Project Title: **Health Technologies Building**

Project #: **2017-02167**

ADDENDUM #02- Dated 02/27/2018

S02.202

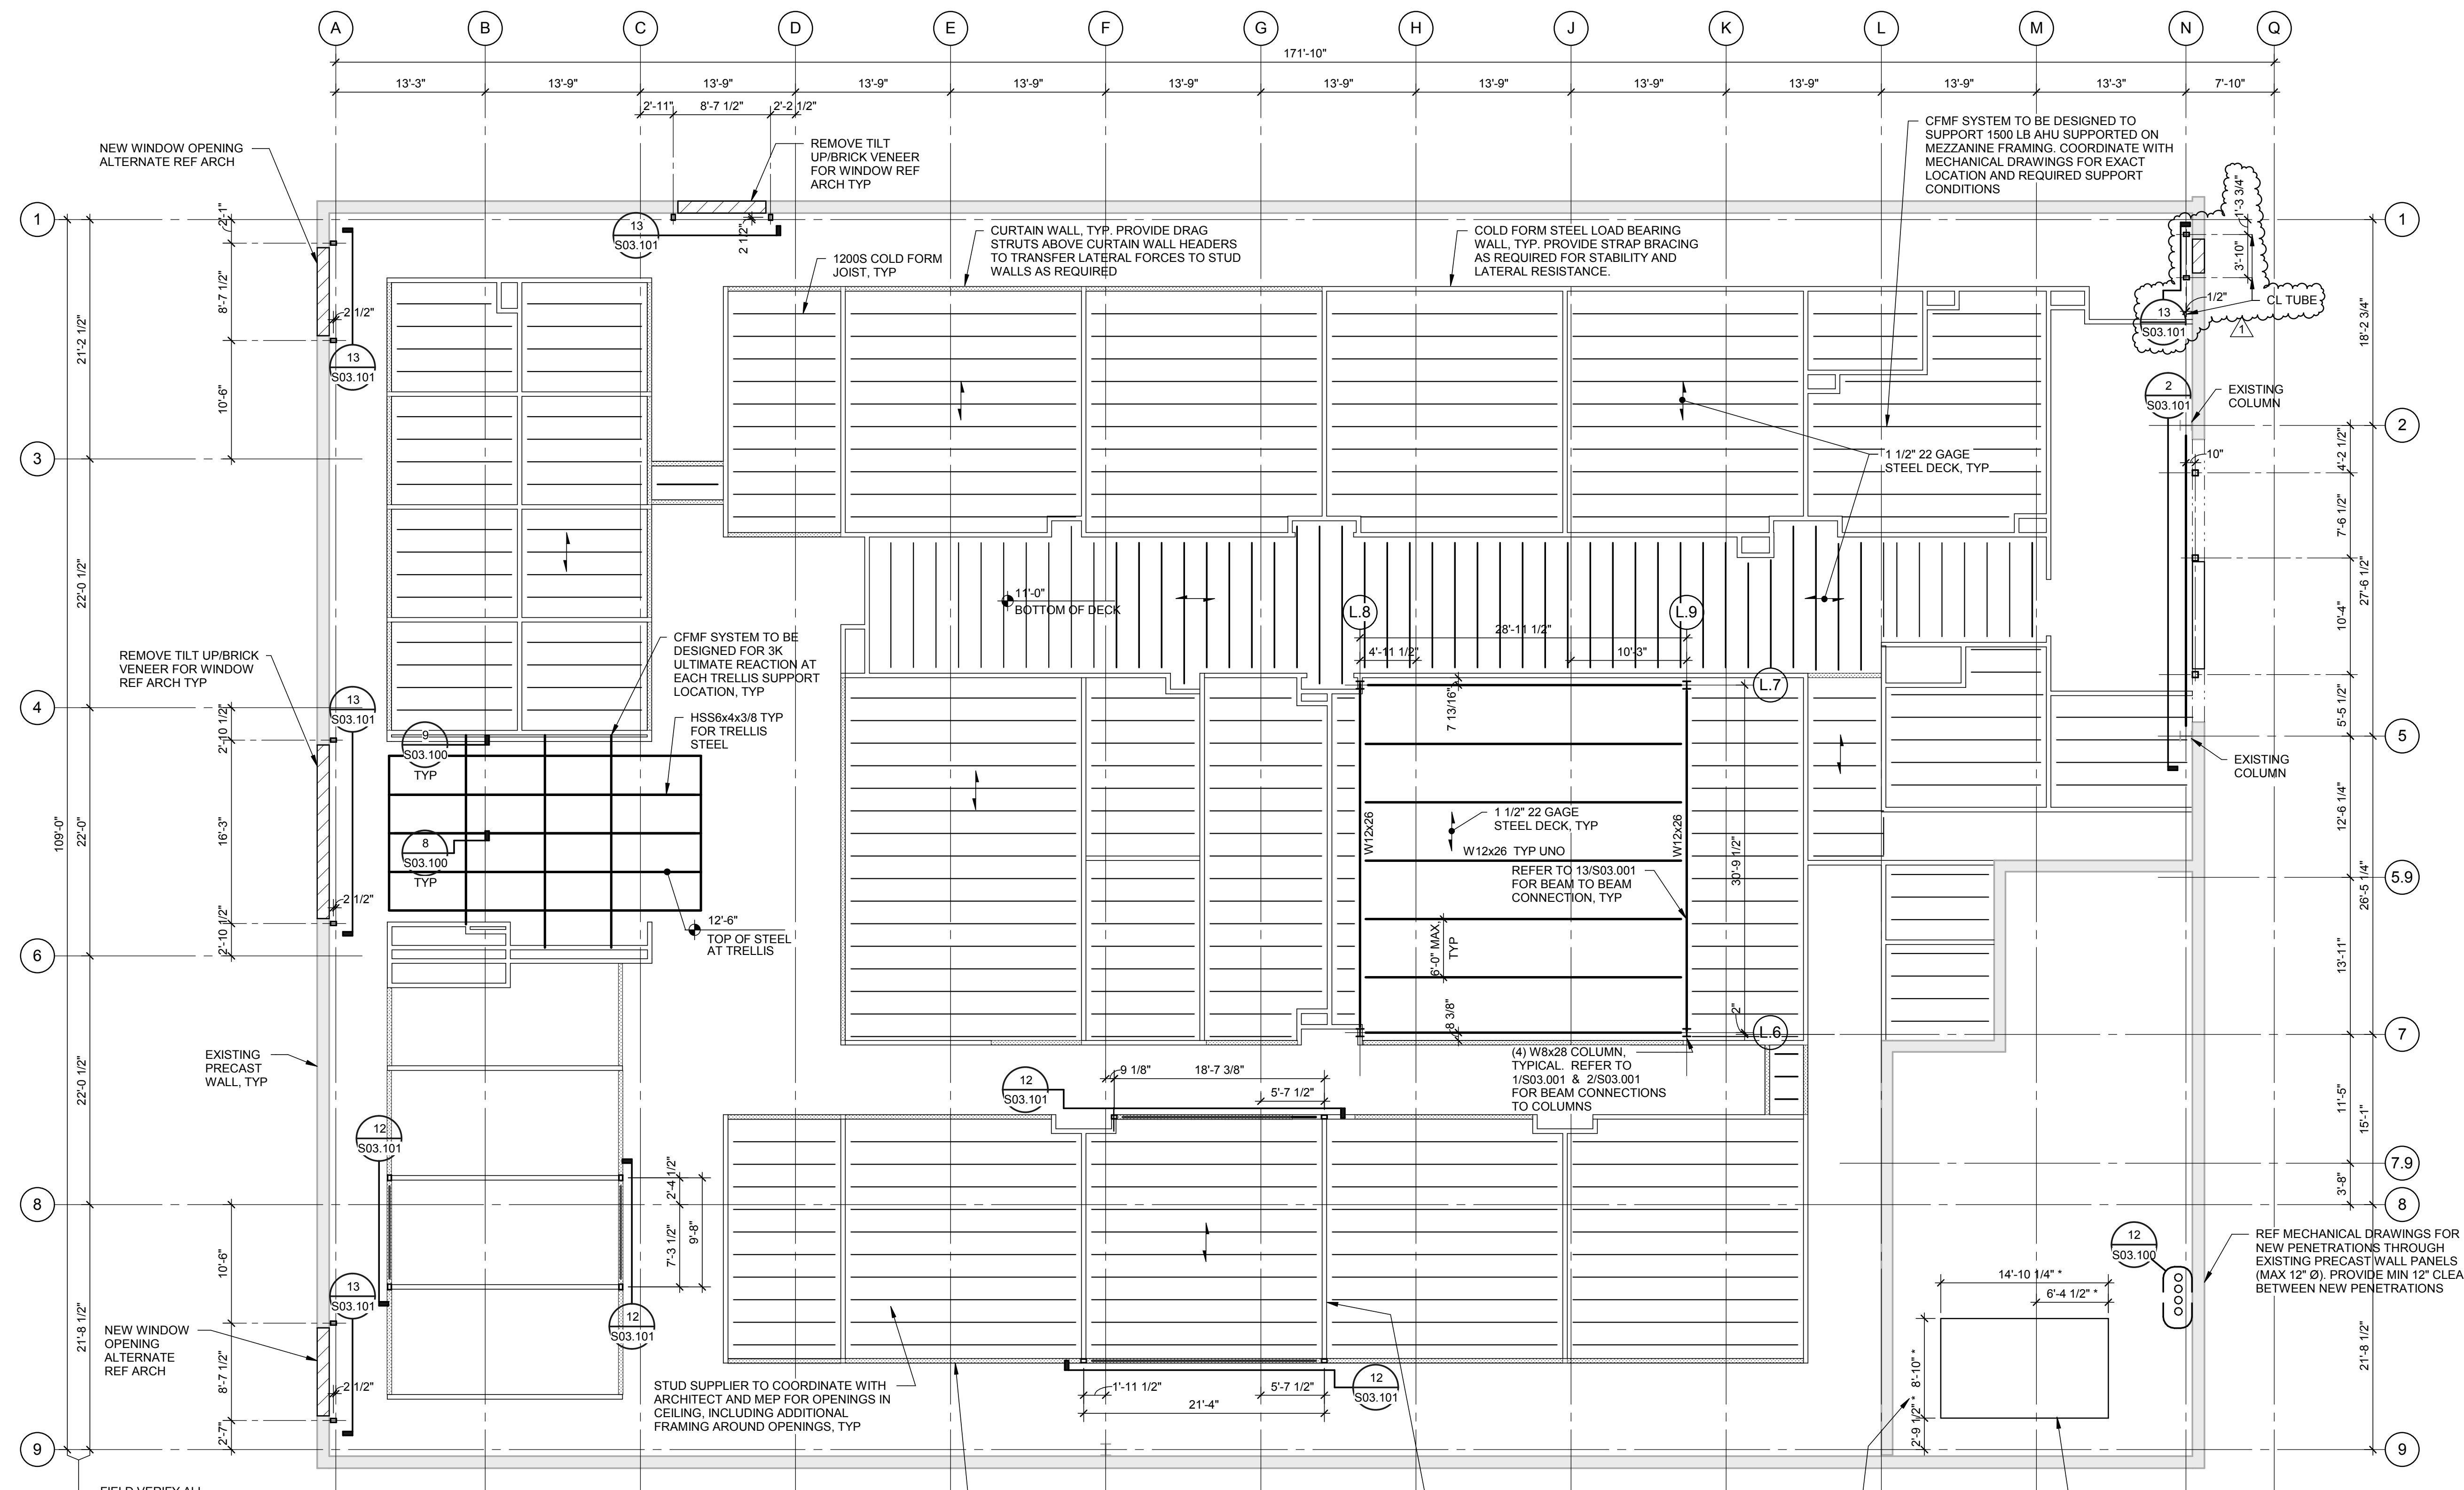
S02.020 – Mezzanine Framing Plan

Added steel to the exit door C6A being added.

21	16. Please confirm that an ODR on-site field office is required as indicated in section 015000 item 1.15.	A site office is required. At the successful bidders discretion, it can be established in existing space in the building (that does not interrupt the flow of the work) or in a trailer.
22	Please clarify the scope of work for the existing transformer located on the southwest side of the building adjacent to the mechanical gates.	This transformer is to be removed per note on MEP site plan issued in Addendum 1.
23	Please confirm that permits are not required for the project as indicated on sheet A00.100 in the General Notes.	City Building permits are not required. Note will be struck from drawings set issued for construction.
24	Please confirm if there are any structural requirements for door C6A similar to the window openings.	Yes, see attached drawing S02-202 for notes and detail reference.
